ADDENDUM NO. 1

Reference: Information Booth
Weber State University – Ogden, Utah
DFCM Project No. 08322810

ADDENDUM NO. 1

Weber State University
New Information Booth Ogden, Utah

AD-01 SCALE 1/8" = 1'-0"

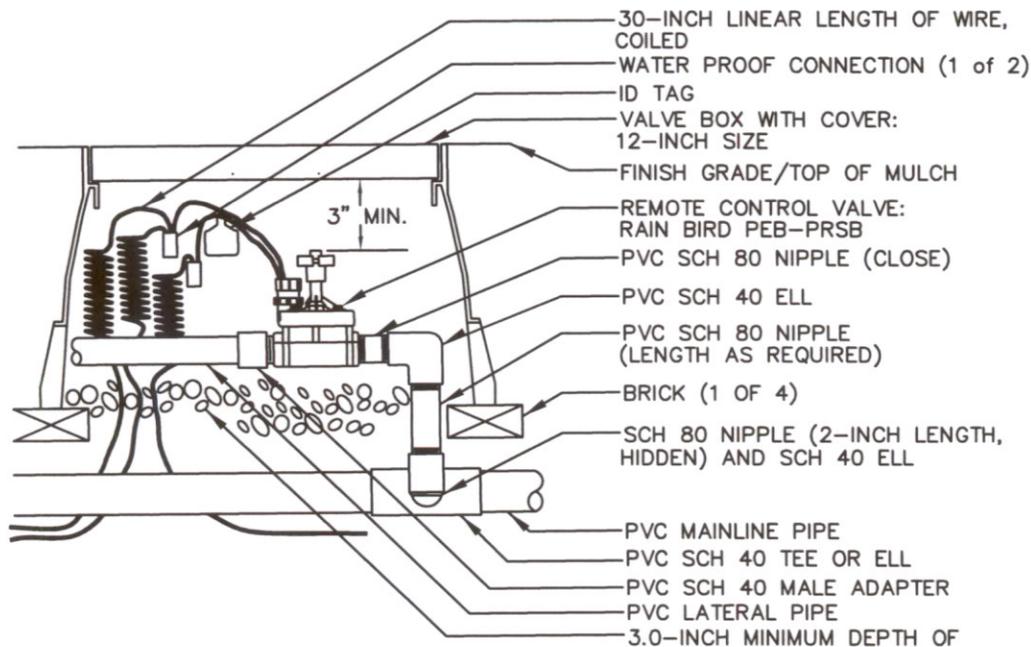
1. All construction will also be required to meet Weber State University construction standards. Weber State University construction standards can be found online at <http://departments.weber.edu/facilities/> . All concrete to have fiber reinforcing as per Weber State University's construction standards.
2. The general contractor will be responsible to provide all construction cones and caution tape to block off the closest North bound lane of Dixon Drive and perimeter of construction area.
3. The general contractor shall provide all sprinkler piping, valves, bubbler irrigation type heads, valve enclosures boxes and sprinkler timer for the new planter areas. Connect to existing sprinkler system with sleeved piping as shown construction documents. See attached addenda drawing AD-02 for additional information.
4. See attached addenda drawing AD-01 for changes to North planter area.

- 1 GENERAL CONTRACTOR SHALL PROVIDE A 6" WIDE CONCRETE RETAINING WALL WITH FOOTING AT LOCATION SHOWN. REINFORCING AND FOOTING AS PER STRUCTURAL DETAIL 4/S300. TOP OF CONCRETE WALL TO MATCH TOP OF ADJACENT CONCRETE PLANTER WALLS. PROVIDE PRECAST CUSTOM COLOR CONCRETE WALL CAP ALONG TOP OF WALL.
- 2 ELECTRICAL TRANSFORMER, SEE ELECTRICAL ADDENDA. TRANSFORMER TO BE SET ON 3" HIGH CAST IN PLACE CONCRETE HOUSE KEEPING PAD.
- 3 MECHANICAL CONDENSING UNIT, SEE MECHANICAL ADDENDA. CONDENSING UNIT TO BE SET ON 3" HIGH CAST IN PLACE CONCRETE HOUSE KEEPING PAD.
- 4 SET TOP OF CONCRETE SLAB "HIGH POINT" AT ELEVATION 99'-7". SLOPE CONCRETE SLAB TO DRAIN TOWARDS THE EAST SIDE OF THE BUILDING
- 5 SET TOP OF CONCRETE SLAB "LOW POINT" AT ELEVATION 99'-4". PROVIDE 4" WIDE x 1" MASONRY COURSE HIGH OPENING AT LOW POINT FOR WATER DRAINAGE.

PROJECT NAME: WEBER STATE INFO BOOTH	
SHEET NAME: SKM-HP100-1	
REVISION NO: Addendum 1	ISSUE DATE: June 10, 2009

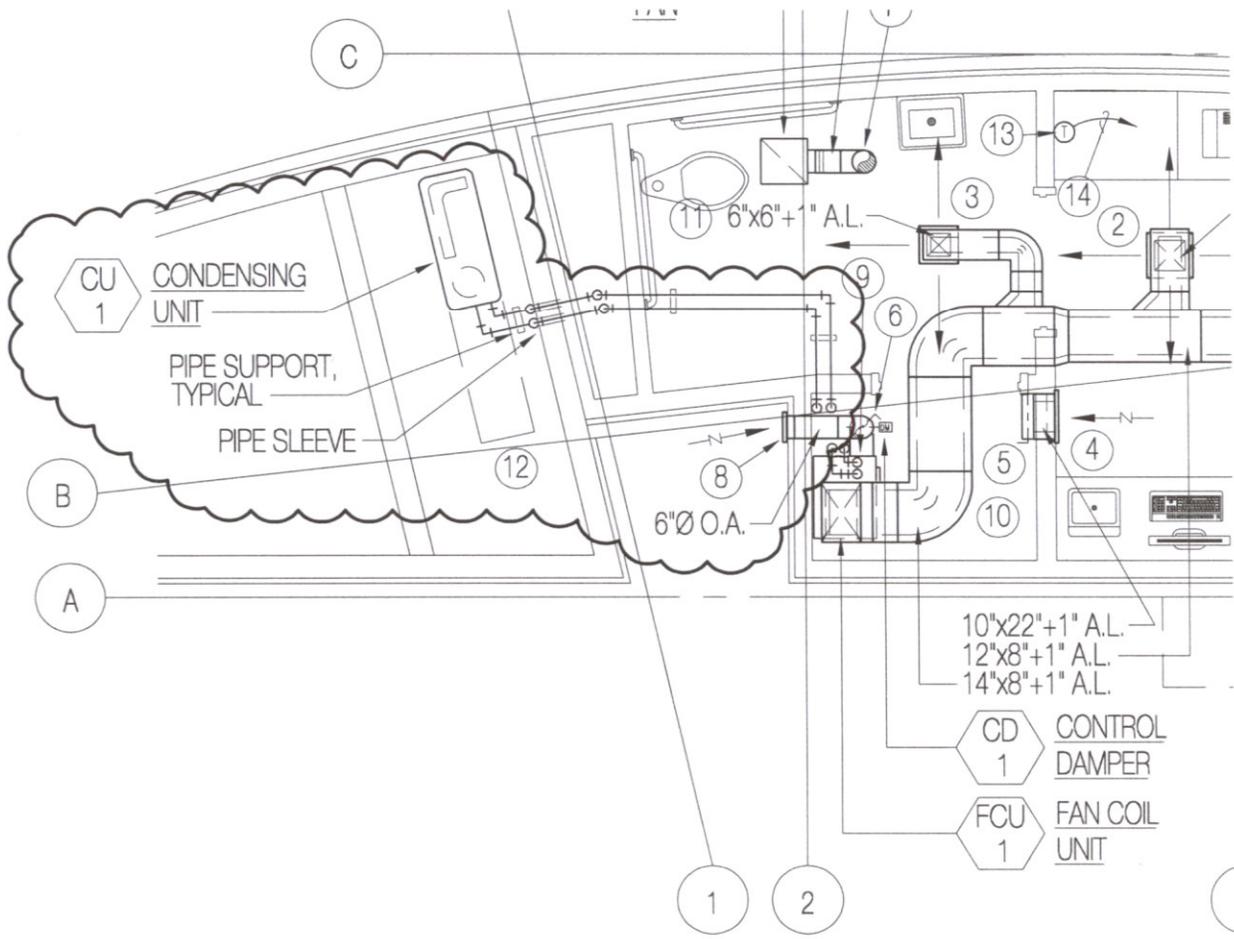
Sheet M-HP100

Item 1: Reference location of condensing unit.

“Move location of condensing unit as shown on attached sketch SKM-HP100.”

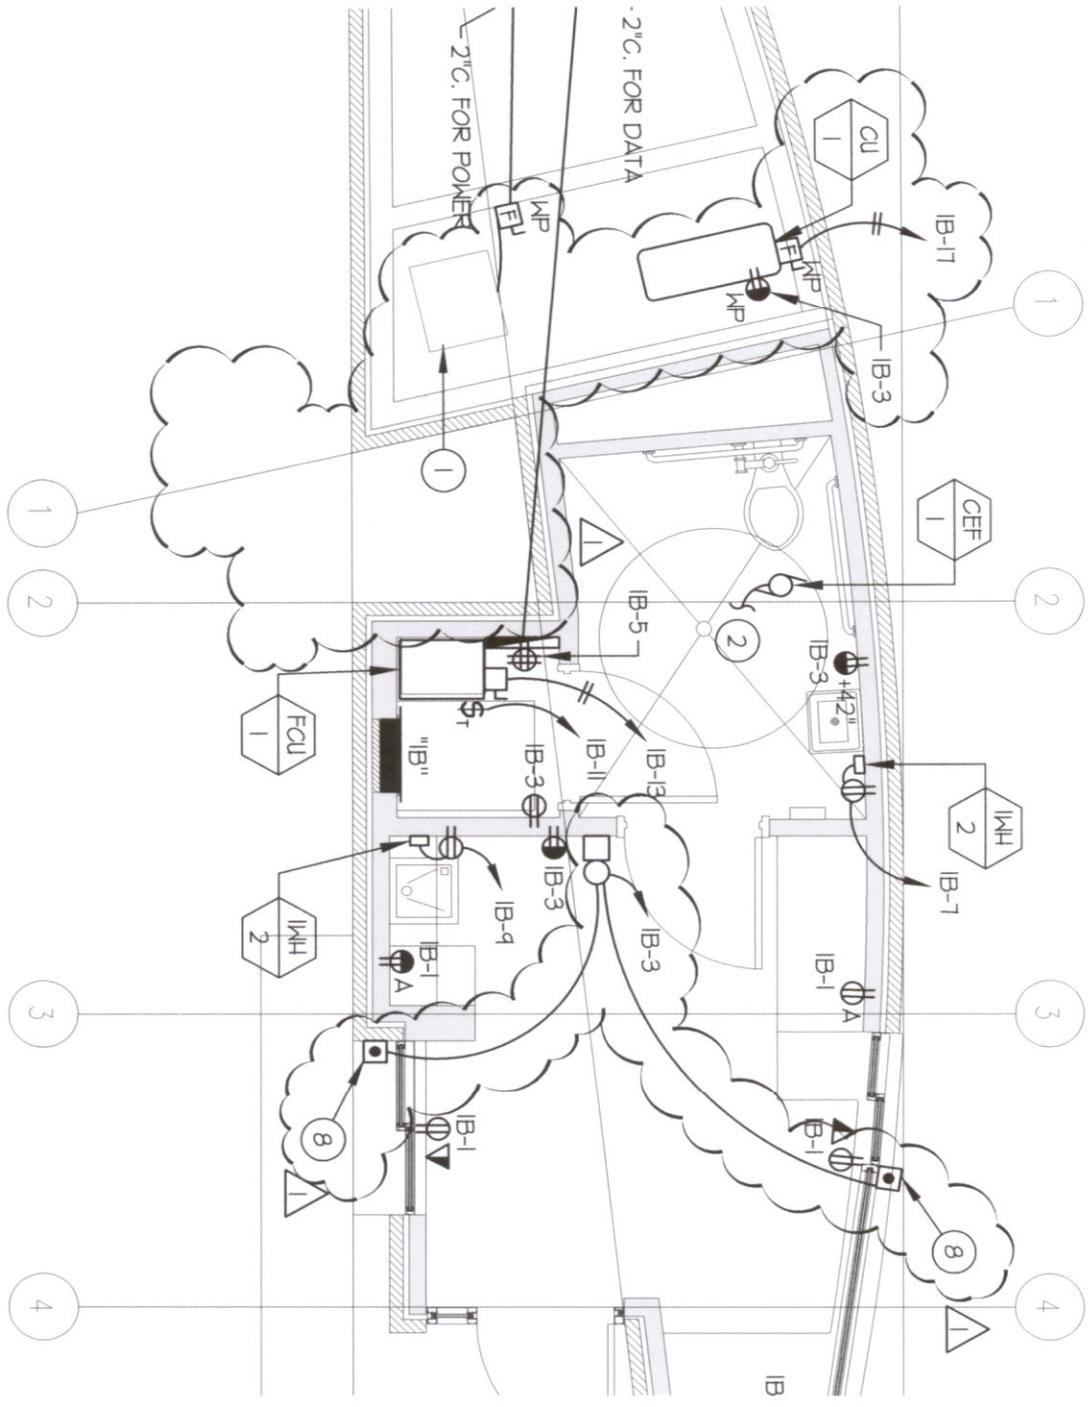
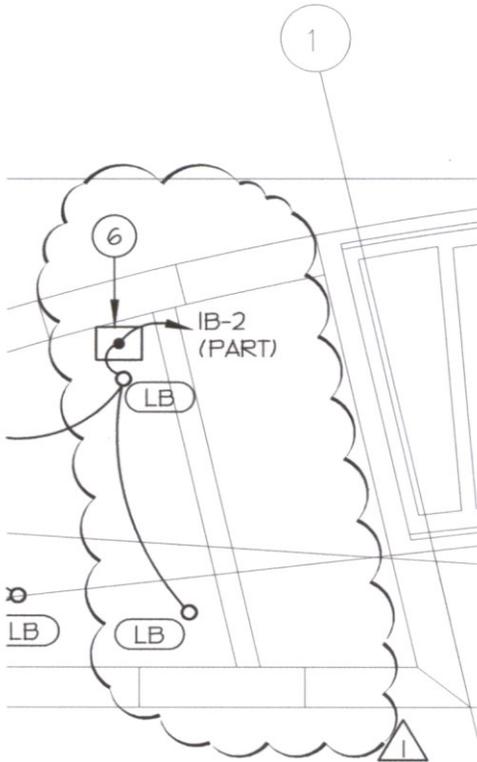
SHEET E-EE100: Power and lighting plan

1. Transformer and condenser locations have been revised and a commercial door bell has been added to the power plan. The landscape lighting has been revised. See ESD's 1 and 2 for more information.

- ① EXISTING 30 KVA TRANSFORMER IN NEW LOCATION. CONTRACTOR TO PROVIDE A WEATHERPROOF KIT. 
- ② SWITCH WITH THE LIGHTS.
- ③ PROVIDE A TORK PHOTO CELL #2107 OR APPROVED EQUIVALENT. LIGHT FIXTURE TYPES 'LF', 'LB' AND 'DFI' SHALL BE CONTROLLED USING THIS PHOTO CELL. MOUNT ON THE ROOF FACING THE NORTH SKY.

- ④ EXISTING CONDUITS. REFER TO SITE PLAN FOR MORE INFORMATION.
- ⑤ CONTRACTOR SHALL INTERCEPT EXISTING CONDUIT & CONDUCTORS. PROVIDE NEW 2" C. WITH CONDUCTORS IN AN NEC SIZED IN-GRADE JUNCTION BOX AND PROVIDE AN IRREVERSIBLE BUTT SPLICE TO THE EXISTING CONDUCTORS AND EXTEND TO THE NEW BUILDING. LOCATIONS SHOWN ARE APPROXIMATE. CONTRACTOR TO FIELD VERIFY EXACT LOCATIONS OF CONDUIT AND CONDUCTORS AND PROVIDE NEW AS REQUIRED FOR THE NEW BUILDING.

- ⑥ PROVIDE IN-GRADE 120V TO 12V TRANSFORMER FOR LANDSCAPE LIGHTING.
- ⑦ CONTRACTOR SHALL INTERCEPT EXISTING CONDUIT & CONDUCTORS. PROVIDE NEW 2" C. WITH CONDUCTORS IN AN NEC SIZED IN-GRADE JUNCTION BOX AND SPLICE ALL COMMUNICATIONS TO THE EXISTING CONDUCTORS PER EIA-TIA STANDARDS AND EXTEND TO THE NEW BUILDING. LOCATIONS SHOWN ARE APPROXIMATE. CONTRACTOR TO FIELD VERIFY EXACT LOCATIONS OF CONDUIT AND CONDUCTORS AND PROVIDE NEW AS REQUIRED FOR THE NEW BUILDING.

- ⑧ PROVIDE COMMERCIAL GRADE DOOR BELL WITH INTEGRAL LOW VOLTAGE TRANSFORMER. COORDINATE EXACT LOCATION AND REQUIREMENTS WITH OWNER PRIOR TO ROUGH-IN. ROUTE 3/4" C FROM SIGNAL BELL TO ACCESSIBLE CEILING SPACE.
